**Appendix N July 7, 2022 Letter with Responses to NYSDEC
Technical Comments dated March 4, 2022**

**Response to Comments Letter Dated: March 4, 2022 Technical Comment Letter
South Brooklyn Marine Terminal – Port Infrastructure Improvements
Project DEC ID: 2-6102-00120**

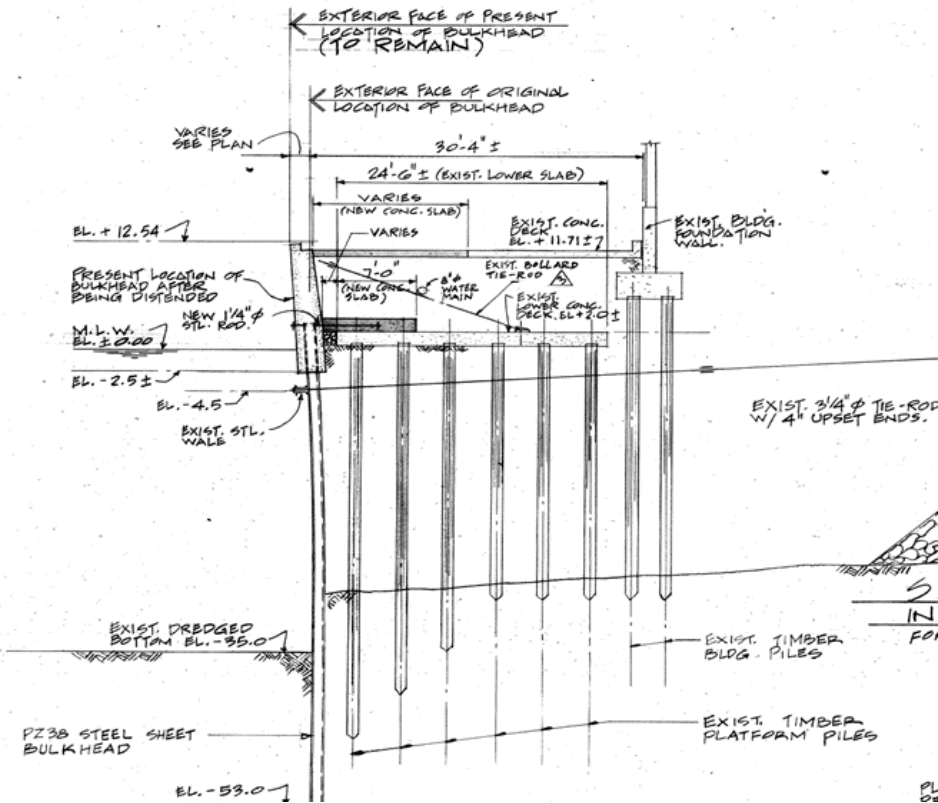
Comment 5: *Bulkhead - The JPA proposes a new bulkhead along approximately 600 feet of bulkhead on the southern side of the 39th St Pier. Plans call for the bulkhead to be placed 35 inches in front of the existing bulkhead surface. While the JPA provides justification for not meeting the NYSDEC's standard to re-build in-kind/in-place, justification must be provided for the relocation of the bulkhead 35 inches seaward. As such:*

Comment 5a: *The Applicant should attempt to reduce the distance of the new bulkhead in front of the existing bulkhead to 18 inches or less.*

Response 5a: The JPA was based on preliminary engineering performed in 2021 and represents a fair assumption around new construction dimensions and existing structural capacities. Given the constraints associated with known and assumed existing conditions at the time of preliminary design and required live load capacities, the preliminary design presented in the JPA drawings represents the alternative with the smallest offset from the existing bulkhead that can be safely installed. This alternative was chosen over other designs, including a pipe and sheet pile combination wall, because of its relatively tight fit to the existing bulkhead. Further detailing will be performed in upcoming design phases, following further underwater inspection to assess the condition and dry inspection of tie rods through test pits.

A robust new steel sheeted bulkhead is needed as there is historical evidence that the existing bulkhead has experienced partial collapses. These local failures were accompanied by lateral displacement of the bulkhead. The amount of displacement varies along the bulkhead plan length (see figure below for additional details). Given the state of disrepair, the live load capacity of the bulkhead is compromised. Dredging the 39th Pier South side back to its original depth of minus 35 feet could initiate failures of the structural system.

Supplemental Information for Response 1a

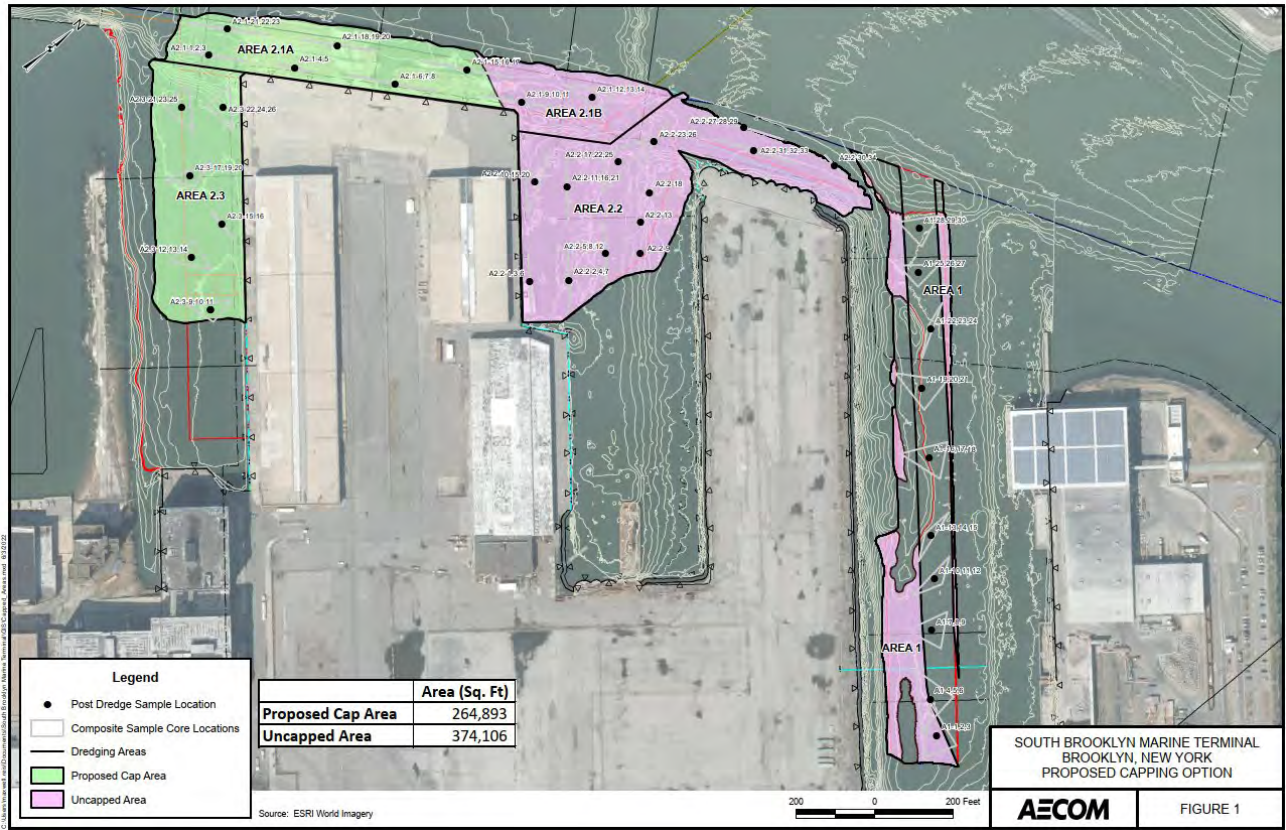
Comment 1a: *The proposed dredging will expose deep sediments that contain higher levels of contaminants (i.e., mercury, dioxins, and other analytes) than what is currently present at the existing mud surface. The Applicant has presented material to NYSDEC showing an anticipated post-dredging sedimentation rate of 0.5 feet to 1.0 feet per year. This sedimentation rate was cited as evidence that a cap is not needed to cover the post-dredge sediments. NYSDEC staff have determined that a cap will not be required for the initial dredge activity based on the reported sedimentation rate. However, NYSDEC is requesting that the Applicant verify the sedimentation rate by providing a post-dredge bathymetric survey, followed by surveys taken annually for three (3) years. If the sedimentation rate in any of the three years is less than that cited by the Applicant, (i.e., 0.5 feet to 1.0 feet), the Applicant will be required to cap the post-dredge sediments. As such, please submit a post-dredging cap plan as contingency for lower-than-expected post-dredging sedimentation rates. Alternatively, the Applicant could consider the use of the cleaner class B dredge sediments to cap some of the class C sediments that will be exposed by this dredge project (see comments 1c and 1d below).*

Response 1a: During a January 26, 2022 meeting, the Applicant explained why capping of the post-dredging surface should not be required, including the limited and degraded habitat, high sedimentation rate, lack of precedent, and site suitability concerns. As shown above, the March 4, 2022 Technical Comment letter required capping in the first three years if the sedimentation rate was not observed in any year. However, stopping wind farm construction-related transport activities to cap in the first three years would be detrimental to meeting common project, State, and City goals. At the May 23, 2022 meeting with NYSDEC when this timing concern was discussed, NYSDEC stated that capping therefore would be required before operations. In response to NYSDEC's comments, the Applicant presented a targeted capping option that consists of placing a clean sand cap in contiguous areas where 2,3,7,8-TCDD TEQ concentrations in the post-dredging surface significantly exceed their TOGS 5.1.9 Class C threshold. The area identified for capping represents a large percentage (approximately 40%) of the proposed dredging area. Based on analysis of the Fall 2021 sediment data, placement of a 1-foot sand cap on the post-dredging surface in Areas 2.1A and 2.3 (**Figure 1**, attached) will achieve sediment quality across the Project Area that is similar to or better than current conditions when considered on an average, Project-wide basis. To ensure the necessary project depths (including 2 feet of overdredge) are achieved following capping, an additional 1 foot of dredging would need to be incorporated into the design in these areas. Consistent with responding to NYSDEC's requirement, the Applicant would place the clean sand cap as described above during SBMT Project construction to avoid interference with cargo carrying

vessel operations. During the May 23 meeting, NYSDEC requested that an analysis of existing vs. post-cap conditions be conducted for all constituents to inform their evaluation of the targeted cap.

Therefore, AECOM performed the same analysis as presented during the May 23 meeting on all constituents that were above Class A thresholds. **Tables 1 through 9** (attached) present area-wide average concentrations of 2,3,7,8-TCDD-TEQ, total PCBs, total PAHs, DDx (sum of DDD, DDE, and DDT) and five metals (arsenic, cadmium, copper, lead, and mercury) in the targeted dredge material and the post-dredging surface (with and without a cap in Areas 2.1A and 2.3). Benzene, total BTEX, chlordane, dieldrin, and mirex are all Class A or were not detected in the targeted dredge material and post-dredging surface and were therefore not included in this analysis.

As shown in **Tables 1 through 9**, following capping of Areas 2.1A and 2.3 (approximately 6.1 acres), the average concentrations of TCDD-TEQ, total PCBs, total PAHs, DDx and metals in the post-dredging surface are similar to or better than pre-dredge conditions on a project-wide basis.¹ In the areas not targeted for capping (Areas 1, 2.1B, and 2.2), average concentrations of all analytes except mercury (discussed below) are below Class C or marginally above (TCDD-TEQ in Area 1) in the post-dredging surface. The in-water portion of the Project Area, comprising the dredging basin footprint, is a total of 13.1 acres, but the total dredging surface area footprint, including side slopes, is 14.7 acres. By capping Areas 2.1A and 2.3, the surface weighted average concentration (SWAC) across the dredging surface area footprint (total of 14.7 acres) would be below the Class C threshold for all of the above analytes except mercury. A SWAC is a widely used metric in sediment remediation and risk assessment for evaluating exposure to contaminants in the bioactive zone by aquatic organisms.² Most forage fish and higher trophic level receptors that may occur in the Project Area have home ranges that are much greater than the size of the Project Area; therefore, the use of a Project-wide SWAC is appropriate and conservative. For TCDD-TEQ (**Table 1**), capping of Areas 2.1A and 2.3 significantly reduces the estimated post-dredging SWAC across the Project Area from 72 ng/kg (above the Class C threshold of 50 ng/kg) to 41.5 ng/kg (or lower in the event that there is less than 6 inches of mixing) which is below the Class C threshold and similar to the average in the targeted dredge material (41.6 ng/kg). Post-cap SWACs for total PCBs, total PAHs, DDx, arsenic, cadmium, copper, and lead (**Tables 2 through 8**) are all well below their respective Class C thresholds. For mercury (**Table 9**), the post-cap SWAC across the Project Area of 2 mg/kg is essentially the same as the average in the targeted dredge material (1.9 mg/kg), and both exceed the Class C threshold of 1 mg/kg. The levels of mercury observed in SBMT sediments are consistent with levels observed in the greater Gowanus Bay.³

In summary, as required by NYSDEC, placement of a clean sand cap in Areas 2.1A and 2.3 (6.1 acres of the 14.7 acre dredging footprint including side slopes; 41%) immediately following dredging would achieve sediment quality across the Project Area that is similar to or better than current conditions. Continued deposition will bring surface concentrations to ambient levels in Upper New York Harbor. This capping concept does not include future cap monitoring or cap maintenance, monitoring of sedimentation rates, or future dredging and capping of other areas so as not to disrupt future cargo carrying vessel operations.
